**SUBMISSION - SSI 9737
SYDNEY GATEWAY ROAD PROJECT**

Re: Sydney Gateway EIS Submission

Table 2.1 **Key items to be addressed by the proponent**

J190839 SIDRA Results for 2017 Baseline Traffic, 2019 with Boral MOD 11/12 Approval and with Gateway Construction Traffic (after Jan 2020)

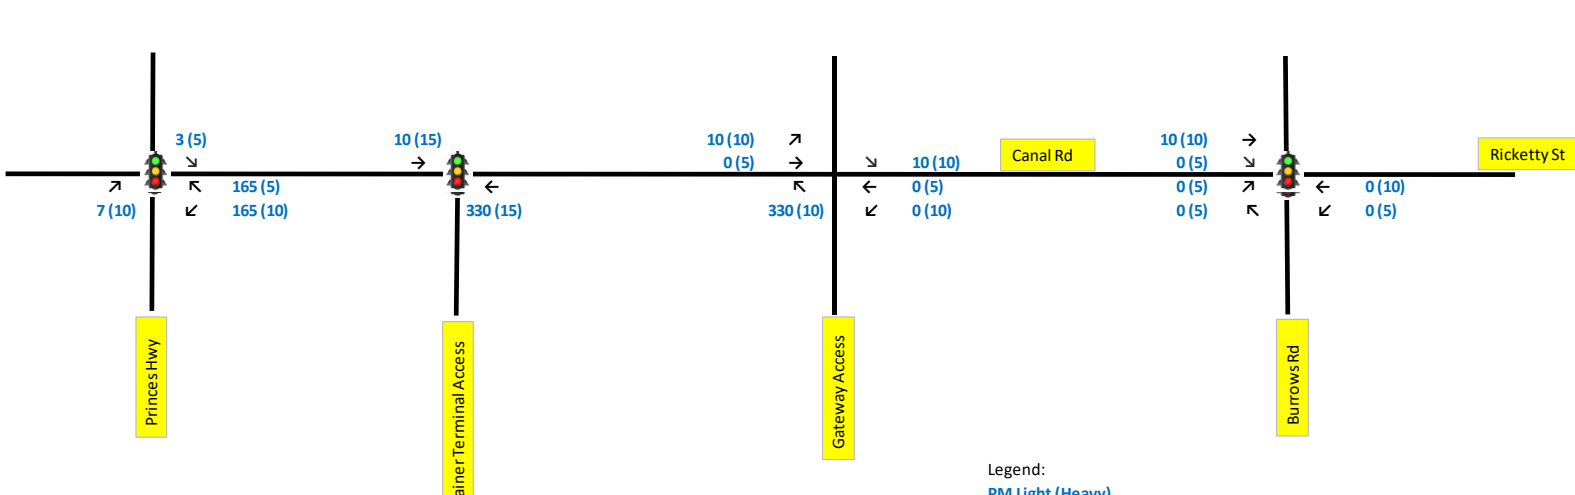
1.3		A preliminary future SIDRA linked intersection analysis has been completed by EMM based on an assumed future distribution of the Gateway construction traffic specified in the EIS. AM and PM peak hour additional traffic plots are illustrated in Attachment A. These results show a further significant worsening of both the AM and PM peak hour traffic delays at most intersections, in particular at the most heavily congested Princes Highway and Canal Road intersection, where the forecast average intersection delays will increase to (Level of Service F) 146.9 seconds and 152.0 seconds in the AM and PM traffic peak hours respectively.
